Application No. 10/713,437

AMENDMENTS TO THE DRAWINGS

ANNOTATED SHEET

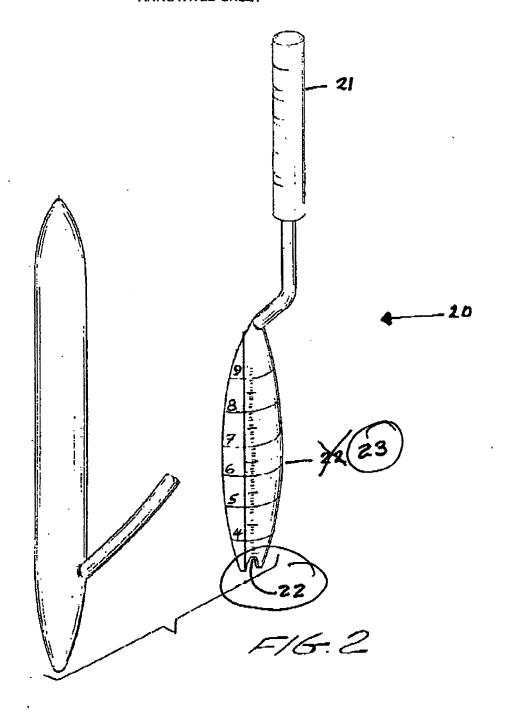
Fig. I has been amended to include additional item numbers that correspond with the description amended in the specification. Specifically, item numbers 15 and 16 have been added to Fig. 1, wherein item number 15 is the outwardly angled shaft section and item number 16 is the linear handle section.

Figs. 2 and 3 have been amended to include additional item numbers that correspond with the description amended in the specification. Specifically, item numbers 23 and 33 have been added to identify the shaft. Item numbers 22 and 32 have been moved to point more particularly to the receptacle (notch) of the tool.

Applicant has amended Fig. I to include additional item numbers that correspond with the description amended in the specification. Specifically, item numbers 15 and 16 have been added, wherein item number 15 is the outwardly angled shaft section and item number 16 is the linear handle section. The location of item numbers 15 and 16 have changed from the last amendment. The outwardly angled shaft section 15 is outwardly angled from the center line of the linear handle section. The portion of the outwardly angled shaft section 15 that is visible on Fig. 1 is replicated on the other side of the tool, and together, the outwardly angled shaft section and its replicate form a convexity, or a roundness in the tool so that it may fit over the rounded prosthesis. Applicant submits that the drawings should now be clear and requests that the objection to the drawings be withdrawn.

Applicant has amended Figs. 2 and 3 to add item numbers 23 and 33 which identify the shaft, in cooperation with the amendment to the specification presented above. Item numbers 22 and 32 have been moved on the drawing to show that they refer to the notch, or receptacle, at the end of the shaft of the tool.
